Value Engineering Study

VE# 201106

US 150 from KY49 to Leslie Ballard Road

Item Numbers 4-8308 and 4-8309

IC-16

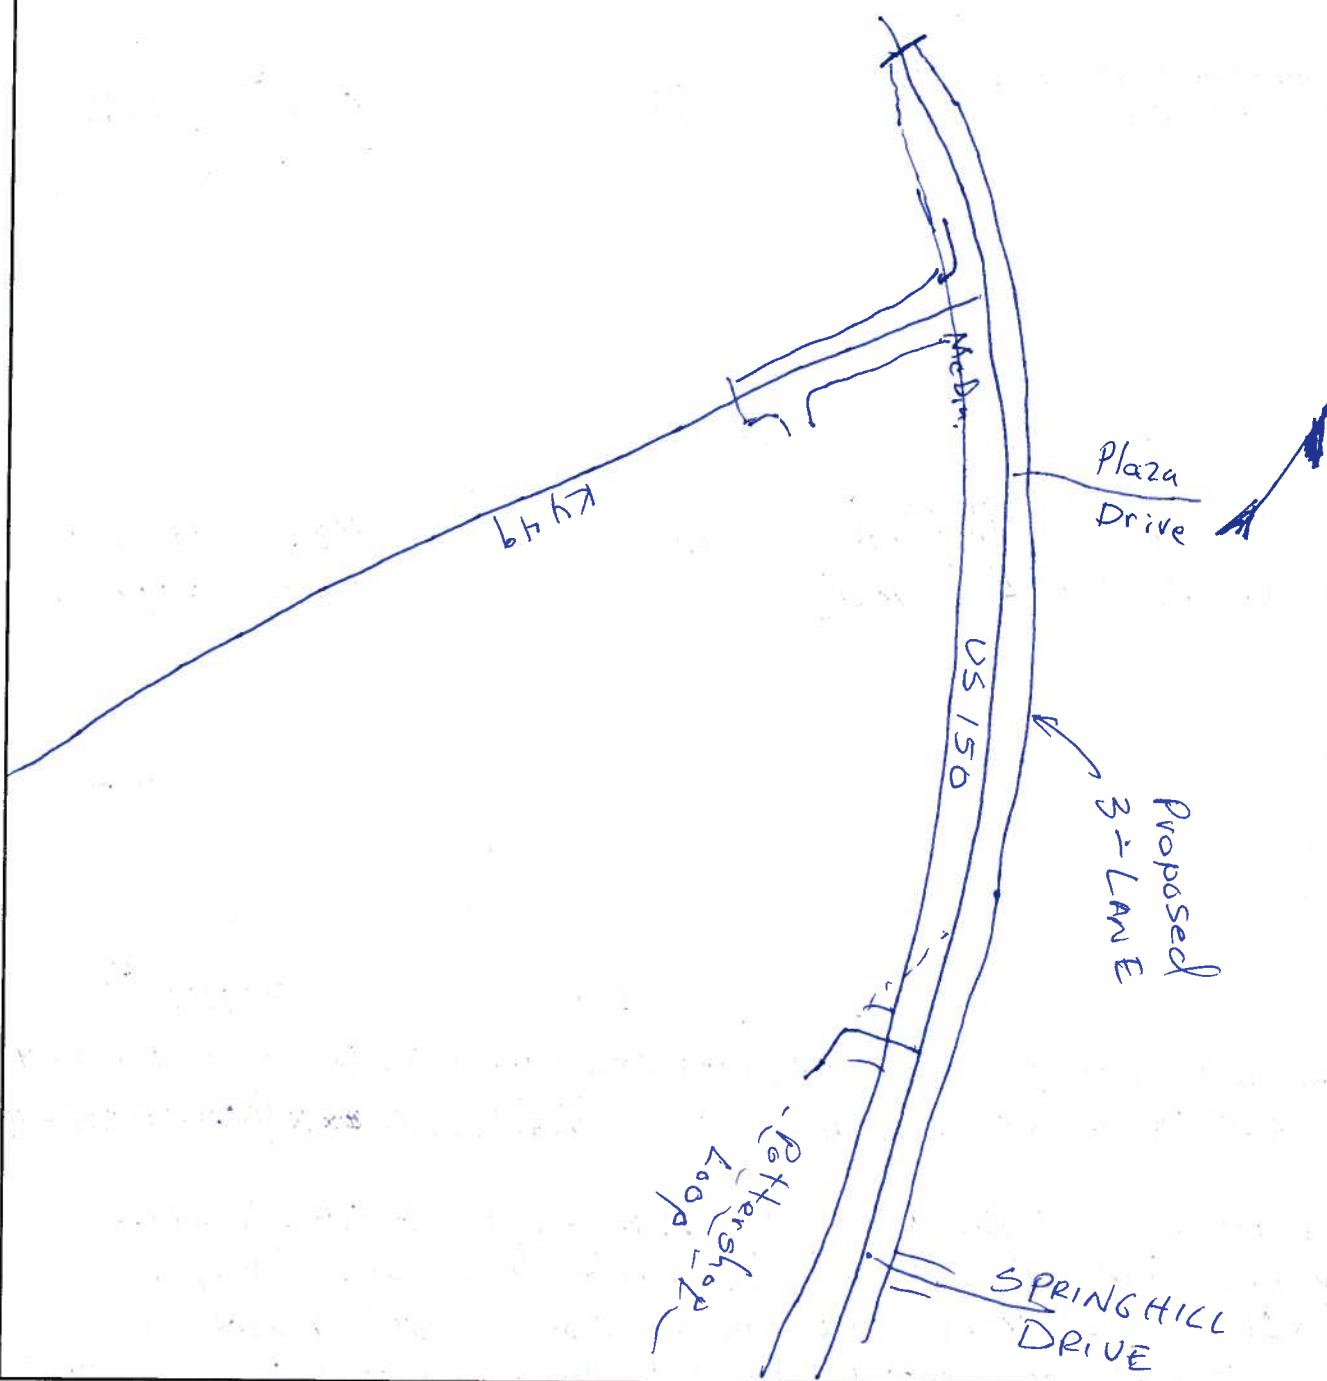
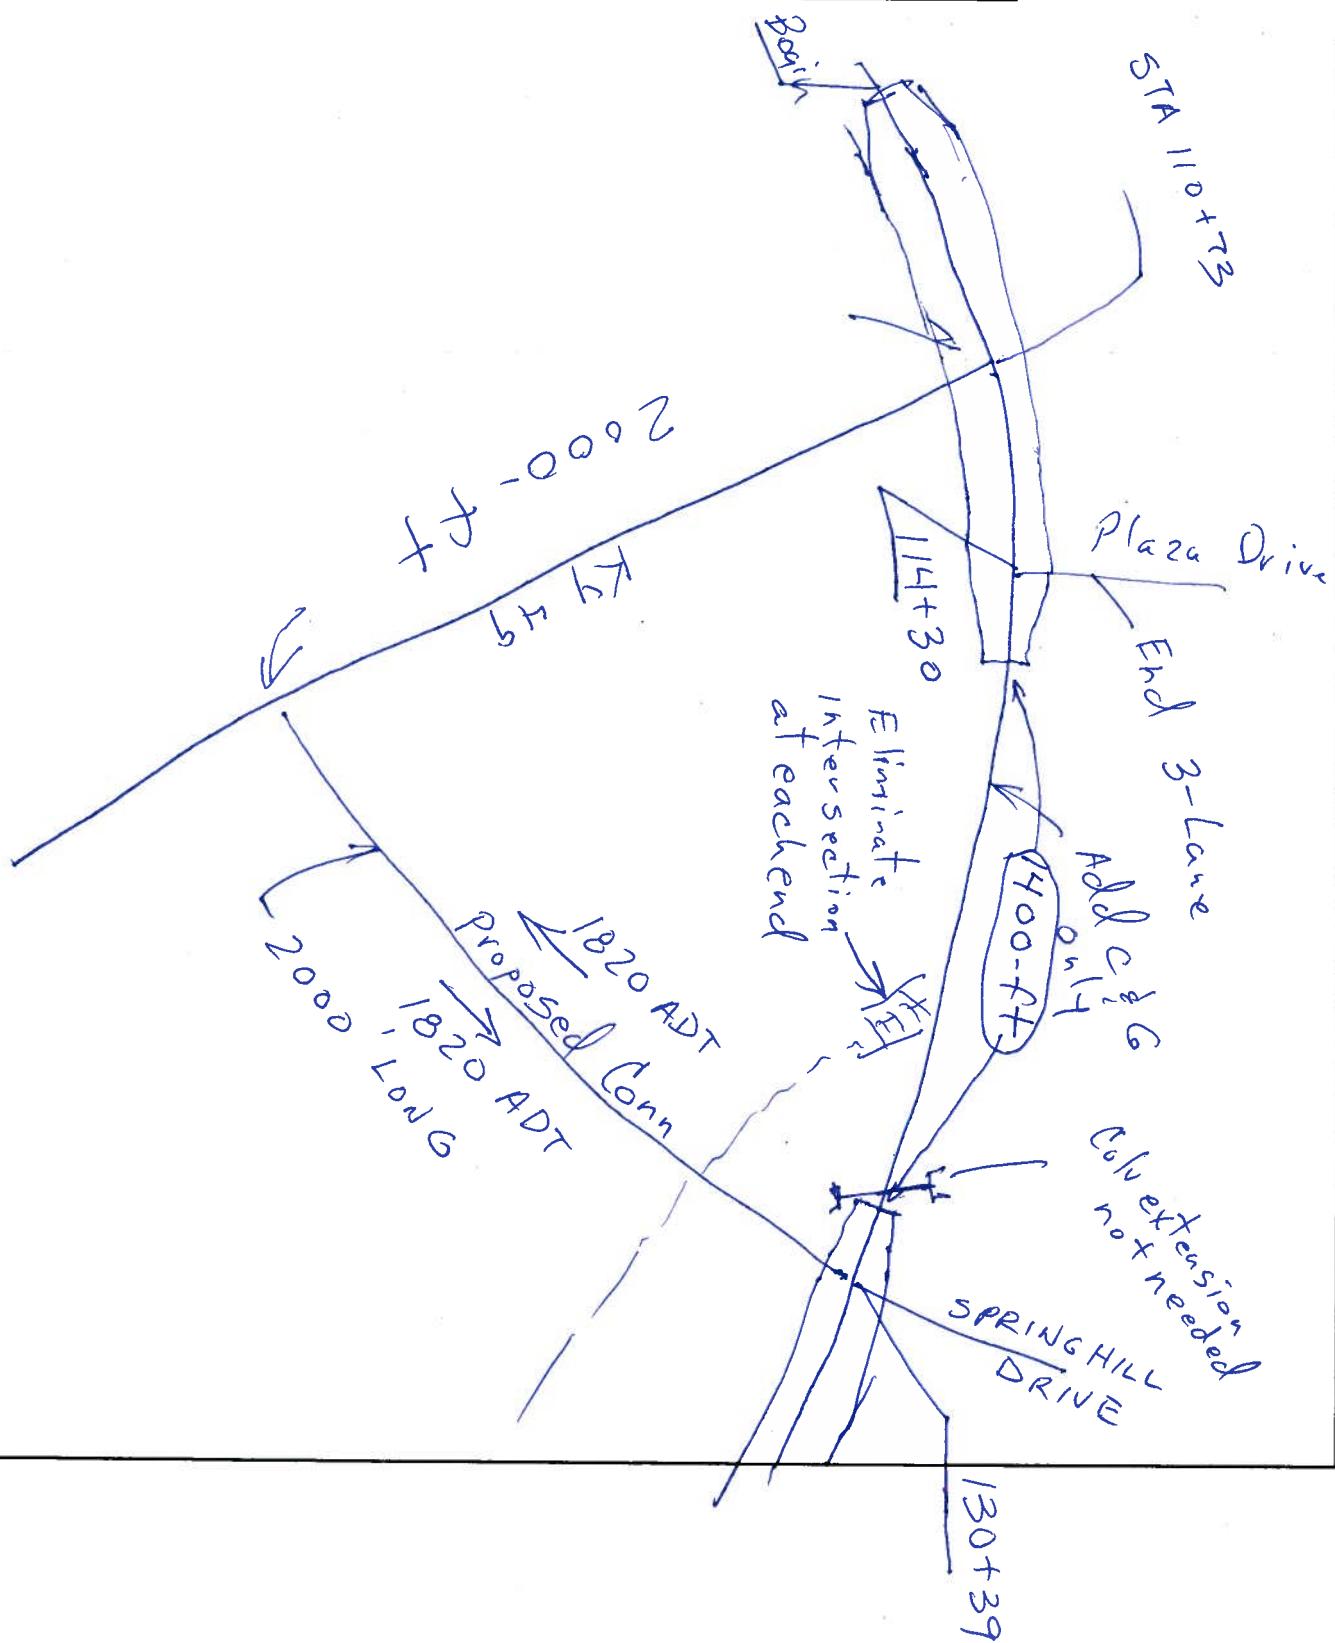
- Provide New Connector From KY-49 Just South of Exist. Residential Area to US 150 AT EXIST. SPRINGHILL Drive (^{Rural} Roadway)
- Eliminate Pottershop Entrances on each end at US 150
- Begin US 150 3-lane Section at Exist. SPRINGHILL Drive thus Eliminating 2300-ft of Proposed 3-lane From KY 49 to Springhill.

DISCUSSION/JUSTIFICATION: Springhill Drive / KY 49 Connector will completely eliminate both Y-intersections at each end of Pottershop Loop as well as most all traffic needing to make the acute right turn from N. KY 49 to E. US 150. It will also eliminate most left turns from W. US 150 to S. KY 49 eliminating the possibility of going left turn traffic from backing up into Westbound US 150 normal traffic flow / lane. Traffic traveling between Parkway and South KY 49 will have their travel distance reduced by $\frac{1}{2}$ -mile by adding ~~3/8~~ - mile !! The need to ~~construct~~ construct the 3-lane section of US 150 from KY 49 to Springhill drive goes away and no longer needs to be constructed because congestion relief obtained by

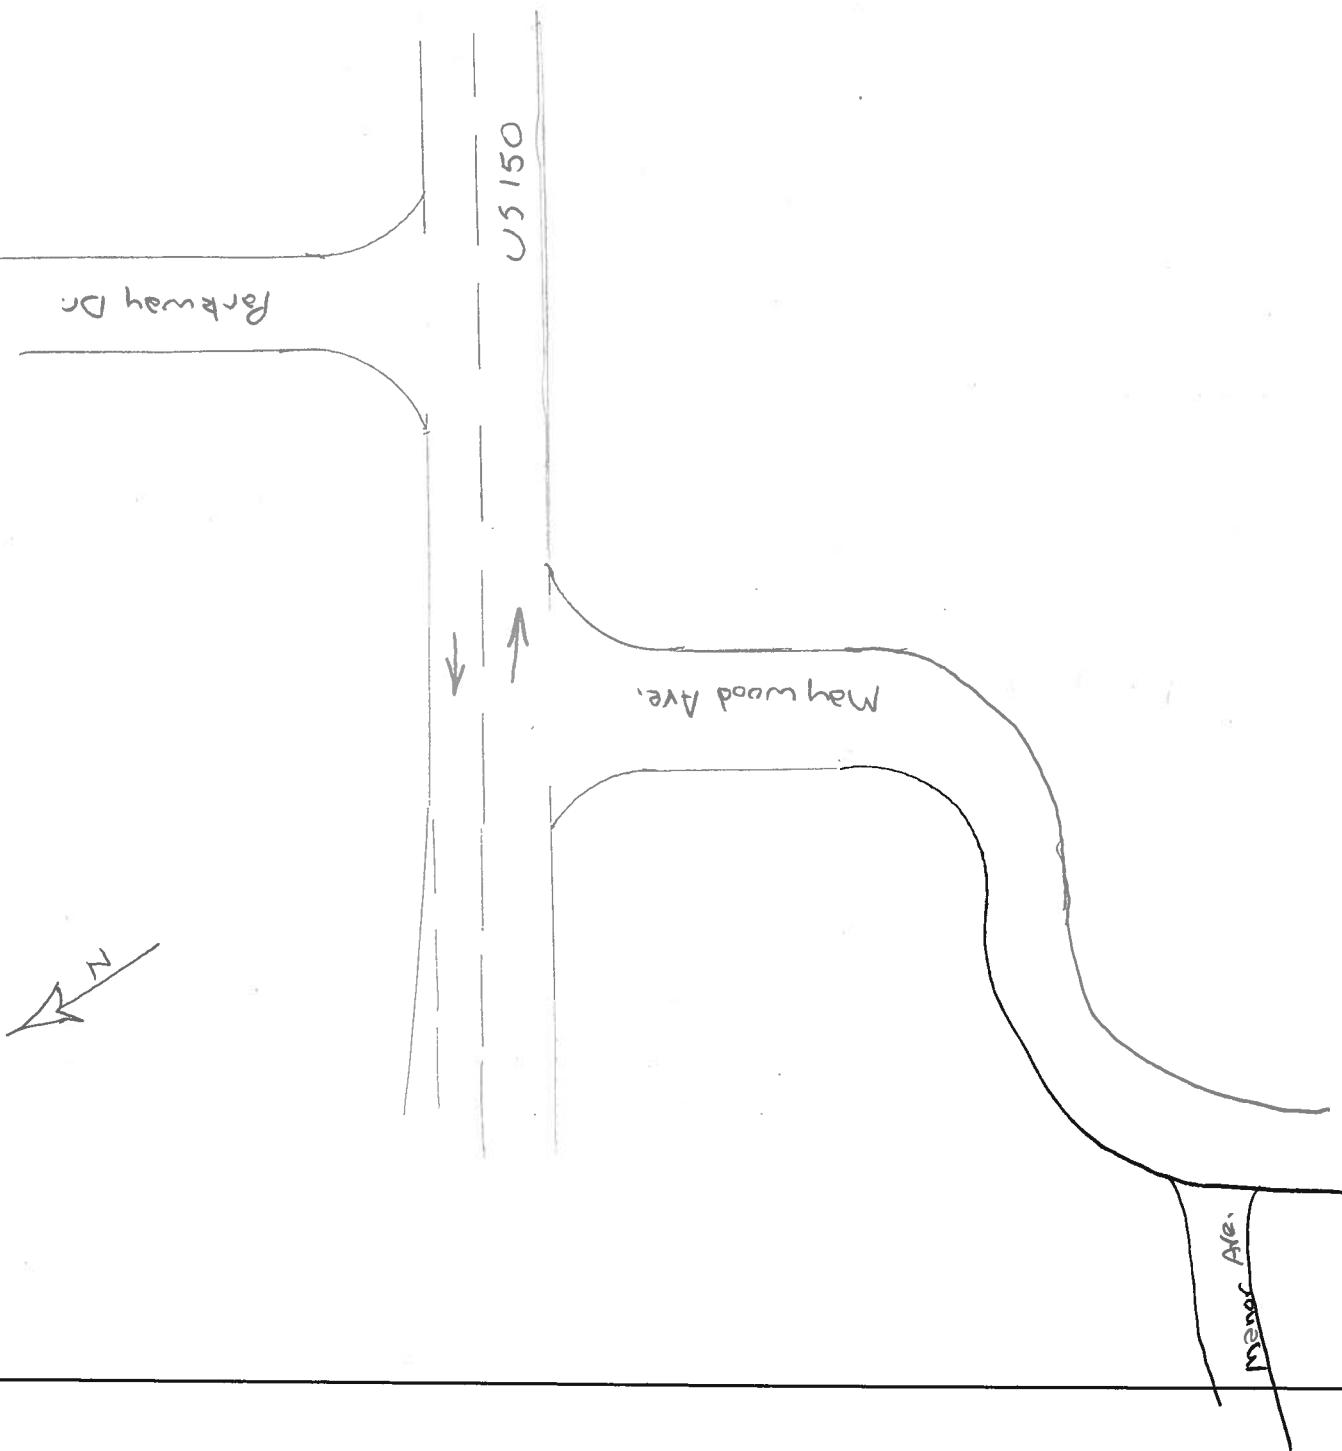
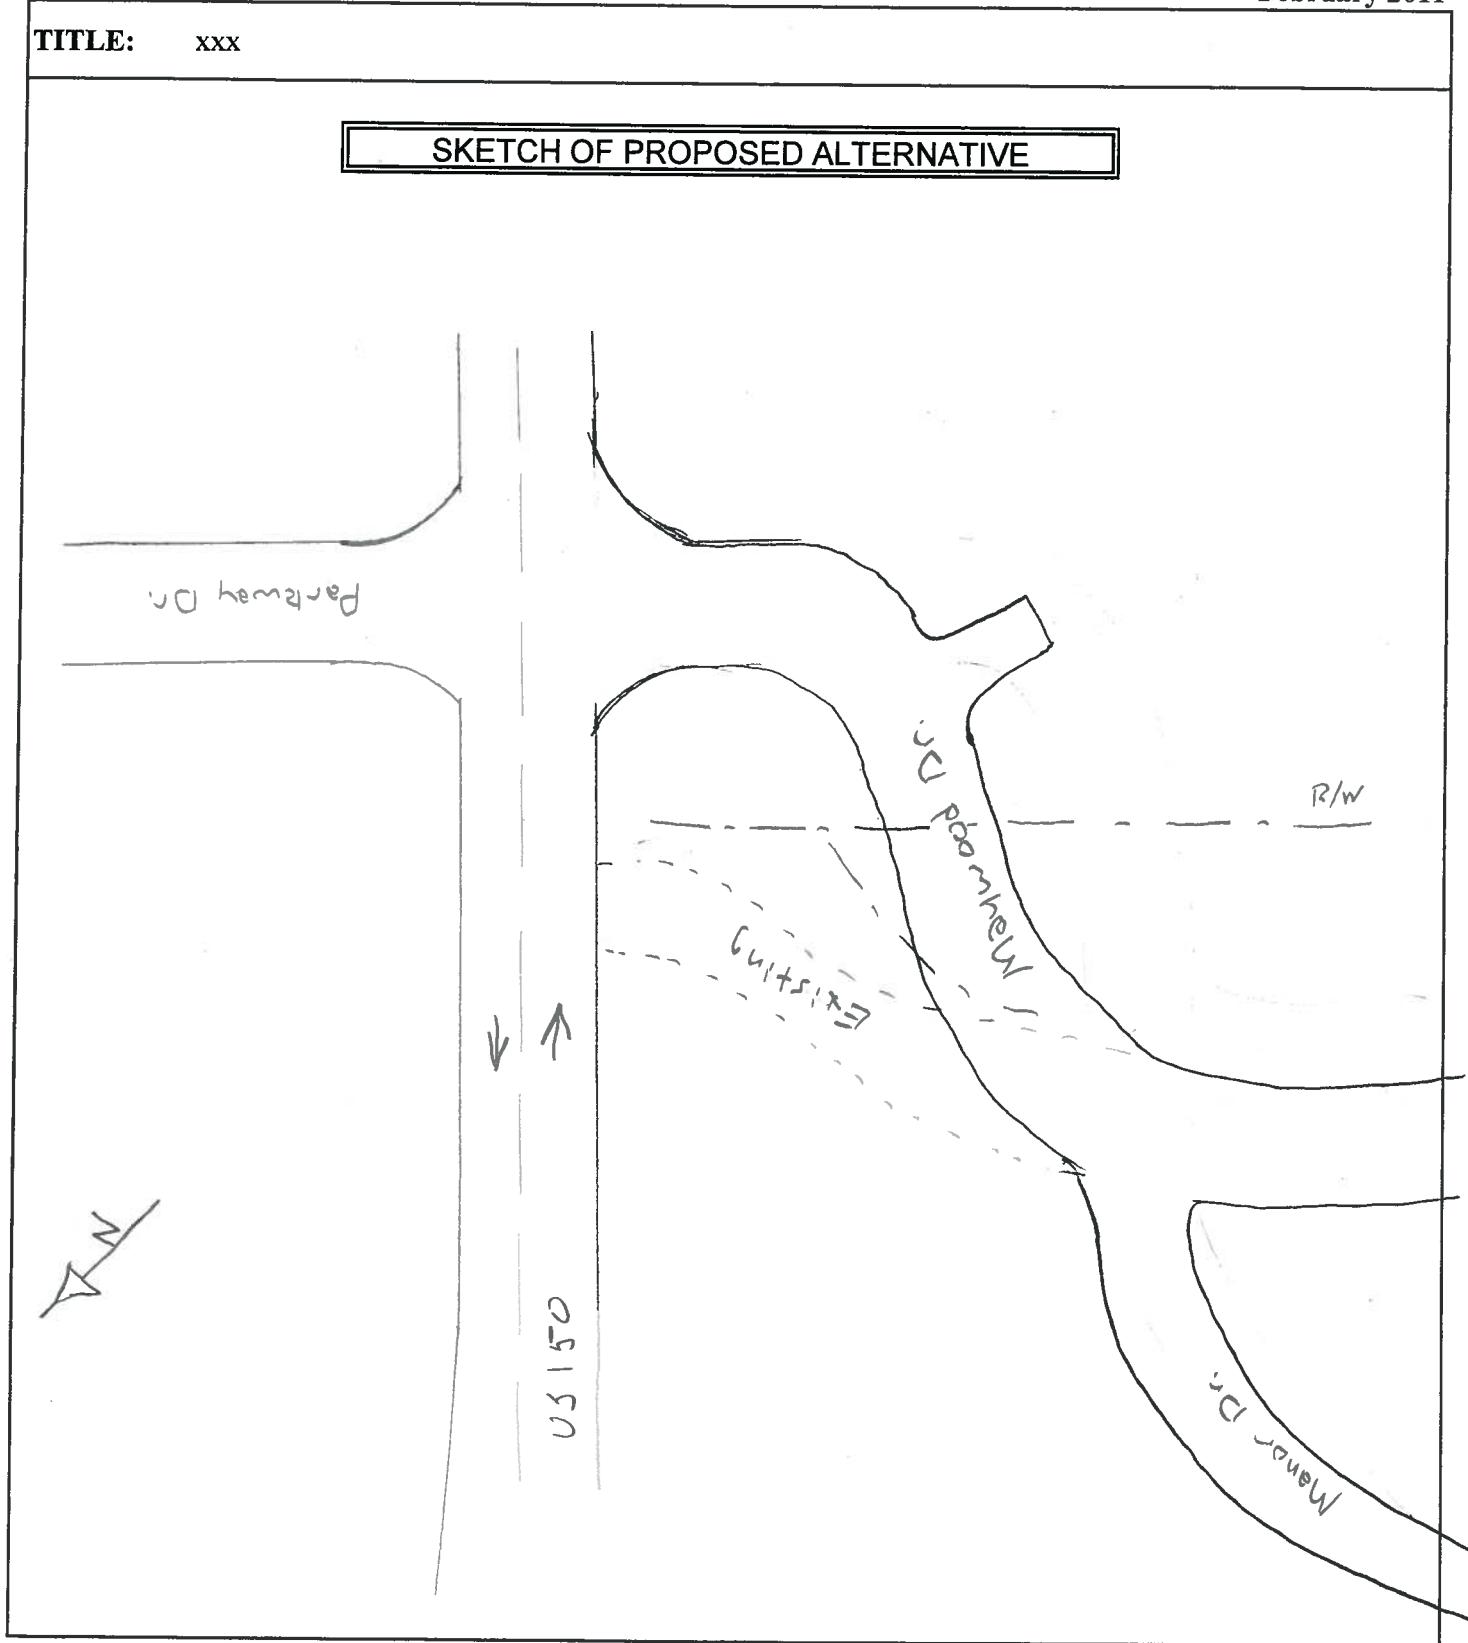
Current project plans propose reconstructing the US150 and Maywood Ave. interchange at the existing location. Also proposed is a new entrance to provide access to parcel 104. The VE team proposes realigning Maywood Ave. so that it will intersect US150 at the proposed entrance to parcel 104, aligning it with Parkway Dr. An entrance to parcel 104 would be proposed off of Maywood Ave. and the existing intersection of US150 and Maywood Ave removed.

IC-28

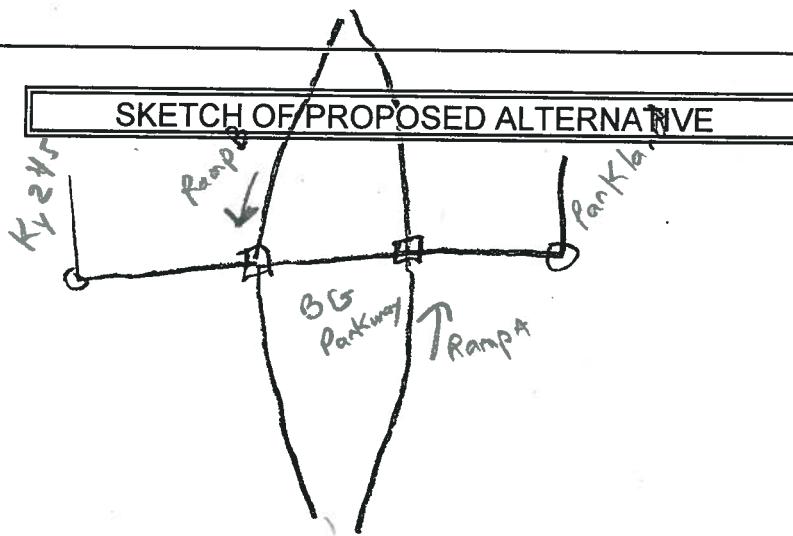
- propose partition signal
- existing signal

SINGLE SPAN - w/ MSE WALLS
Hybrid PCI Beams

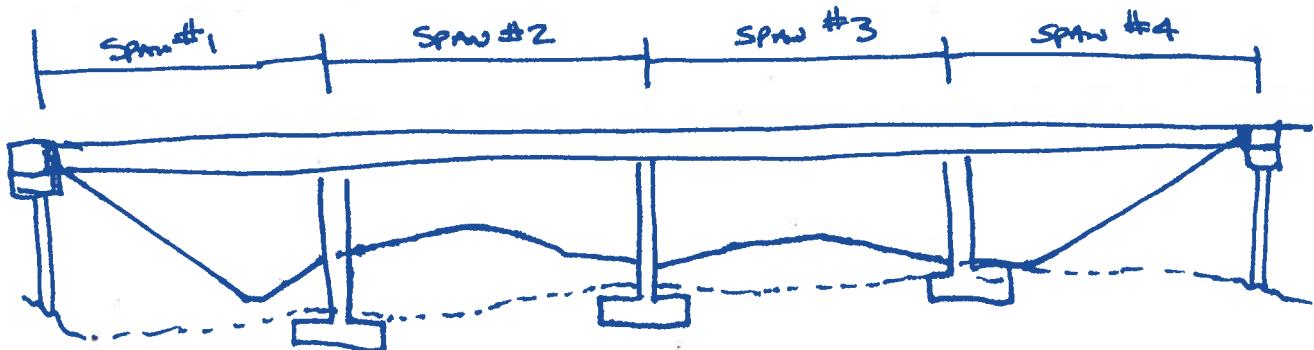
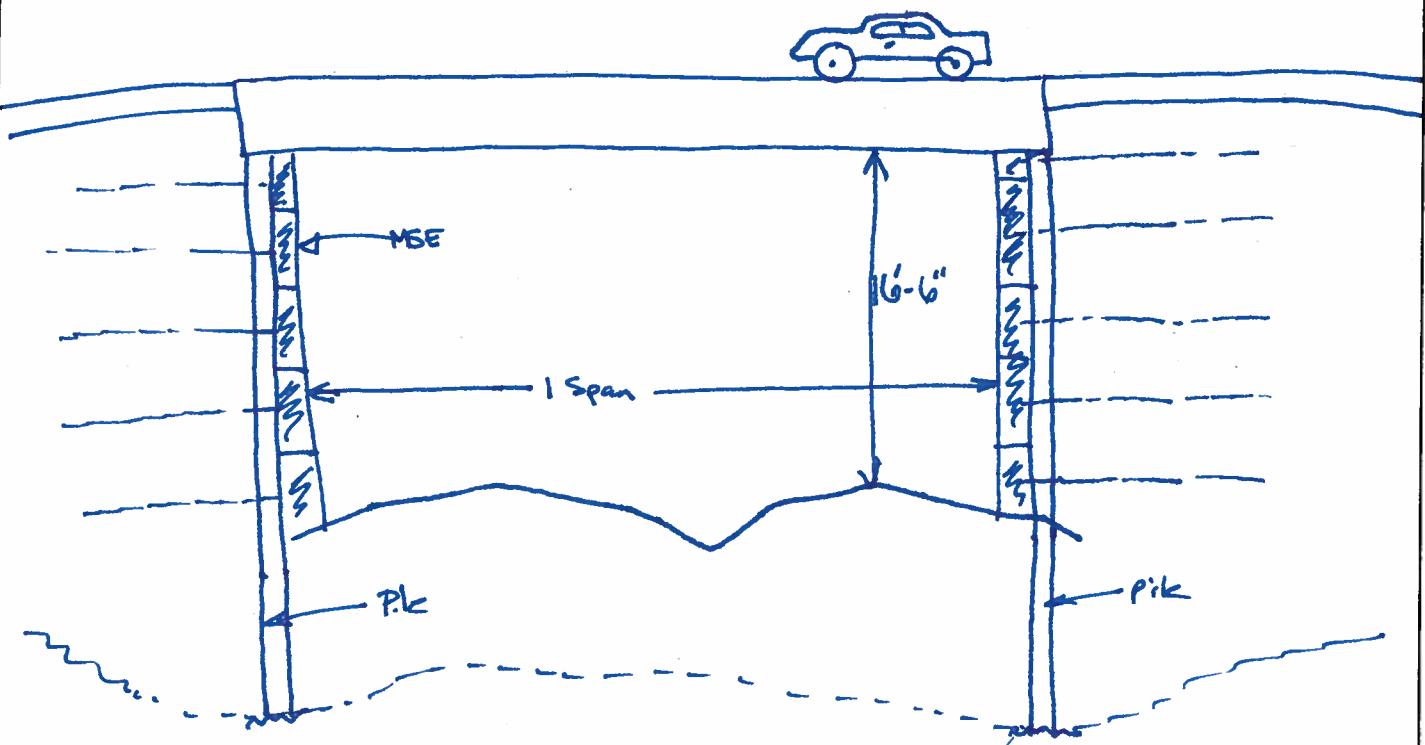
Replace existing Bridge w/ 4 span PCI Beams to widen
to match the widened roadway.

Replace with a single span bridge using a hybrid PCI Beam
and MSE walls

Replacing a bridge is a costly event. It is anticipated that \$1.7 million is the construction cost for the proposed/base line design of a four-span PCI Beam. Using MSE walls to create a ~~single~~ span use/service will eliminate the construction of 3 piers. This elimination would reduce cost of materials, construction time and improve maintenance of traffic on the BG Parkway. To add this scenario, it would limit future cost in maintaining a shorter bridge. This type of bridge will serve the purpose of spanning the Parkway and accommodating the capacity of US150. It also adds the option of many ramps closer and very less ROW.
